SUBJECT: COMANCHE PEAK NUCLEAR POWER PLANT, UNITS 3 AND 4
DOCKET NUMBERS 52-034 AND 52-035
RESPONSE TO REQUEST FOR ADDITIONAL INFORMATION NO. 4579, 4606, 4608,
AND 4609

Response to Request for Additional Information No. 4579 (CP RAI #159)

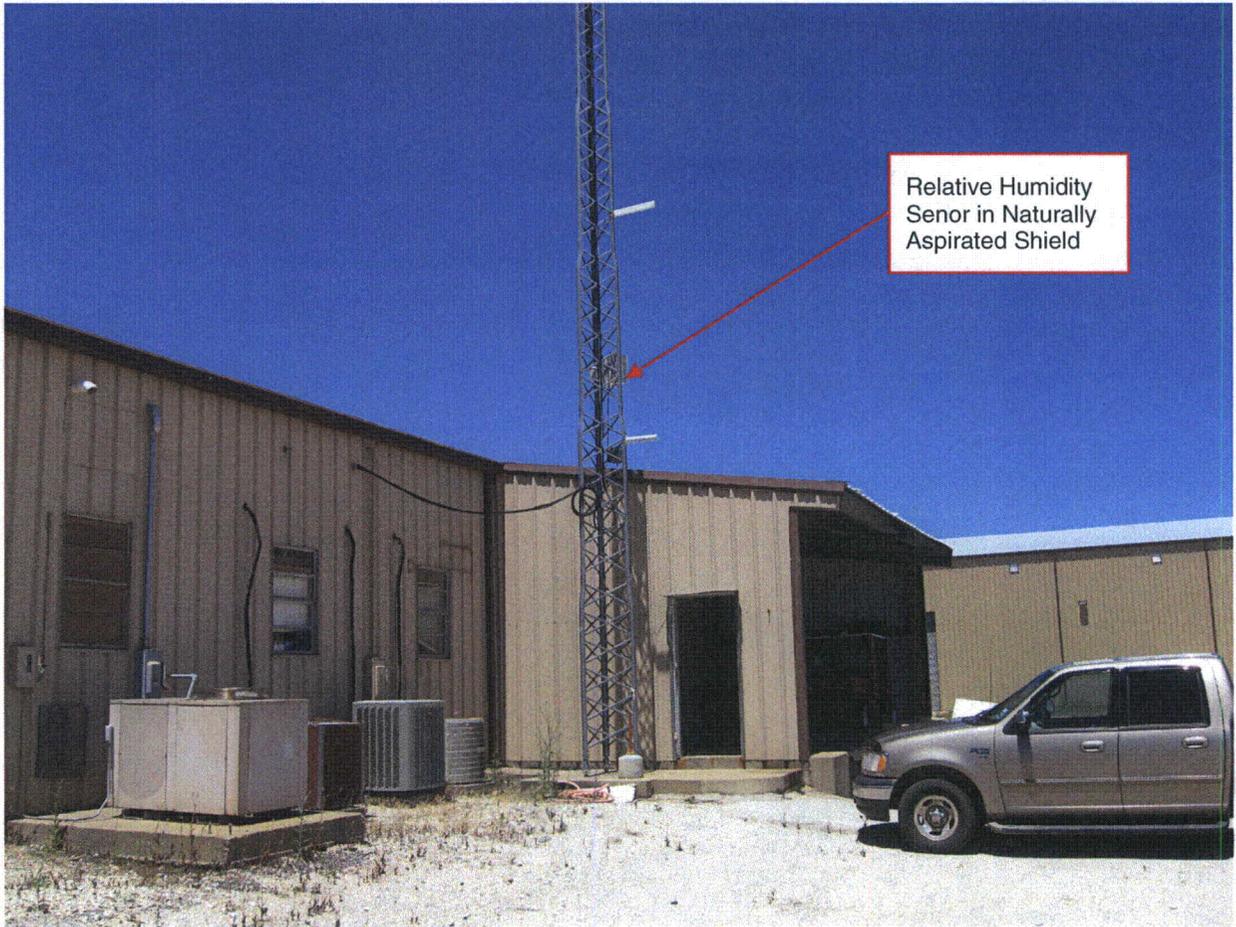
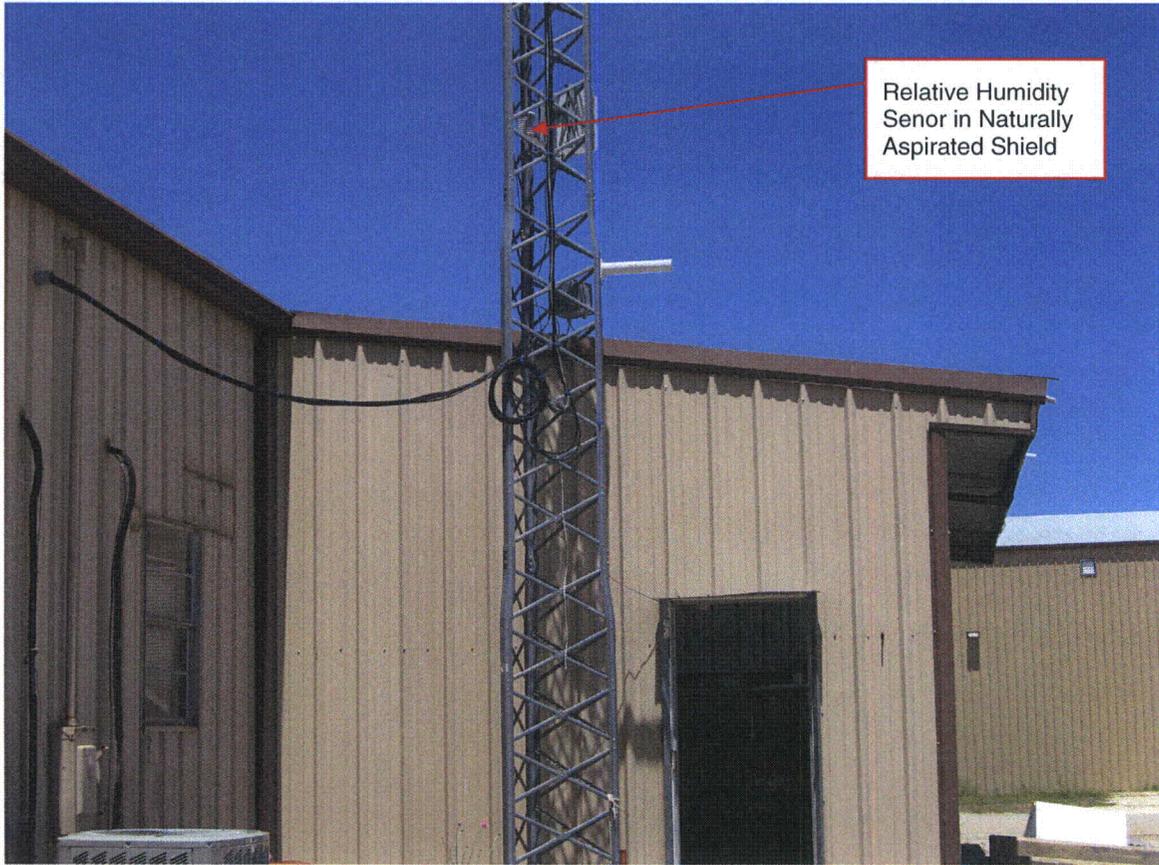
In response to RAI 2.3.3-3, Luminant provided information regarding the onsite moisture measurements collected from June 12, 2008 to September 23, 2008. The updated FSAR Section 2.3.3.1 states that "the pre-operational onsite data was used to demonstrate that the actual onsite conditions correlated well with longer term data from local weather stations which were used for the official calculations". The staff requests that the comparison of onsite data with first order weather stations be provided, along with the correlation demonstration of the data.

Further, the updated FSAR Section 2.3.3.1 states "the instrument was located on top of the Project Records Center Building". Please provide clarification that demonstrates the moisture data collected was obtained without interference from manmade objects and was not skewed because of the building's roof or surface materials.

The comparison of the pre-operational onsite data with data from local weather stations has been added to FSAR Subsection 2.3.3.1.

the shield with maximum artificial radiation indicate that under conditions of low air movement (1m/s) the temperature sensor is maintained within 2.7°F (1.5°C) of ambient. This improves to 0.7°F (0.4°C) or less at wind speed greater than 3 m/s. The location of the relative humidity sensor and the surrounding shield is depicted in the attached photographs (Figures 1 through 3). The photographs show that the instrument was sufficiently removed from manmade objects so that the data was not skewed because of the building's roof or surface materials.
